Attachment 1:

Table of Attachments

Unless indicated with an asterisk, all documents are excerpts from the Administrative Record. Docket locations and file names indicate where, and under what name, the documents can be found in the Regulations.gov docket, docket number EPA-R02-OAR-2024-0312.

Attachment 6: Response to Comments Accompanying Final Permit (Document A.3 in the Docket entitled “A.3 ASOW EPA Response to Comments Sept. 29 2024r”). Attachment contains document excerpts.

Figure 1

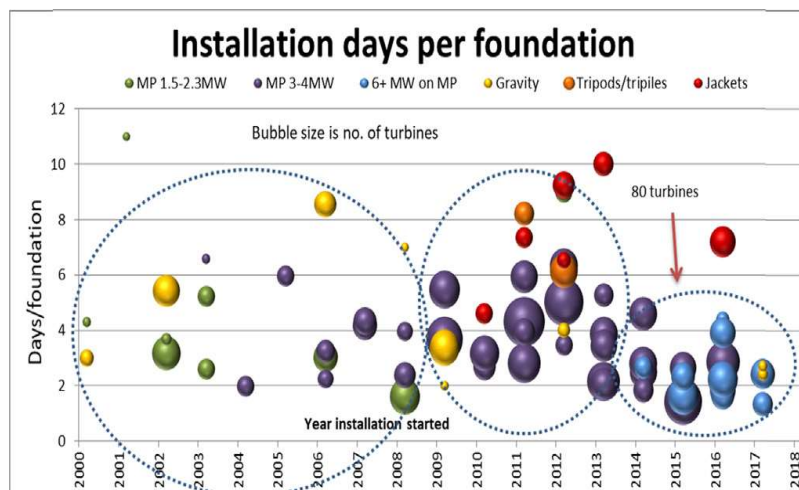
The Epsilon Associates estimate of 2.6 days for foundation installation is supported by real world experience with installation times as shown below.

Figure 2-2: Visibility Metrics levels at Brigantine Wilderness Area

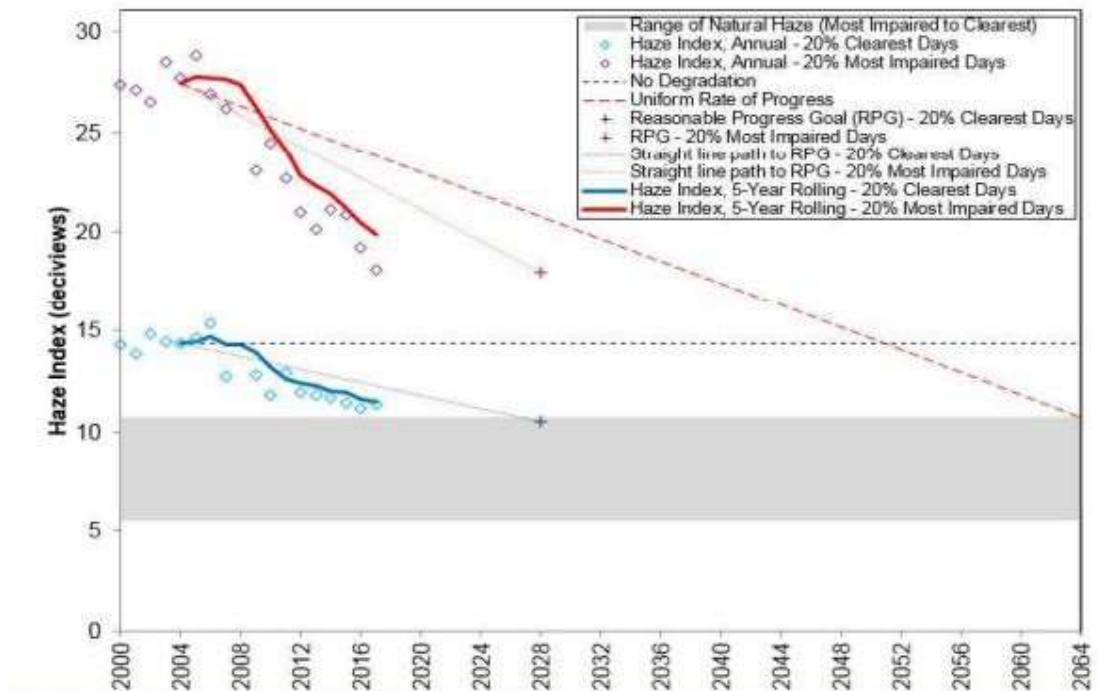
- s) Figure 2-2 of the New Jersey Regional Haze SIP shows that the projected 2028 visibility at the Brigantine Wilderness Area is well below the URP level. Additionally, the figure indicates that the observed 2016 visibility at Brigantine is approximately 6 deciviews below the URP glide path. The average observed visibility from 2018-2022 (see figure below) shows more than 6 deciviews below the URP glide path. Therefore, any potential increases in visibility degradation at Brigantine due to the project would not endanger Brigantine's visibility remaining below the URP glide path and meeting the regional haze rule goals.

Figure 2-2: Visibility Metrics levels at Brigantine Wilderness Area

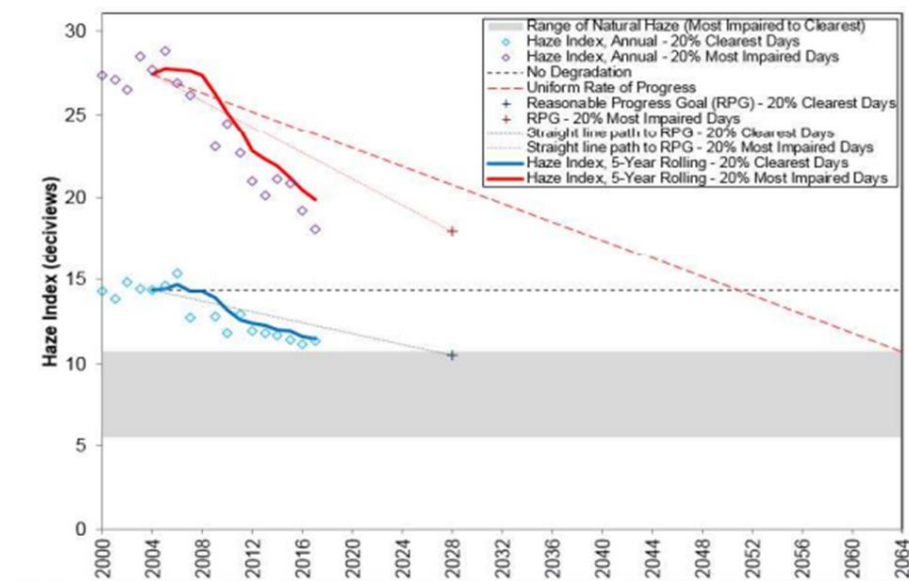
- Figure 2-2 of the New Jersey Regional Haze SIP shows that the projected 2028 visibility at the Brigantine Wilderness Area is well below the URP level. Additionally, the figure indicates that the observed 2016 visibility at Brigantine is approximately 6 deciviews below the URP glide path. The average observed visibility from 2018-2022 (see figure below) shows more than 6 deciviews below the URP glide path. Therefore, any potential increases in visibility degradation at Brigantine due to the project would not endanger Brigantine's visibility remaining below the URP glide path and meeting the regional haze rule goals.
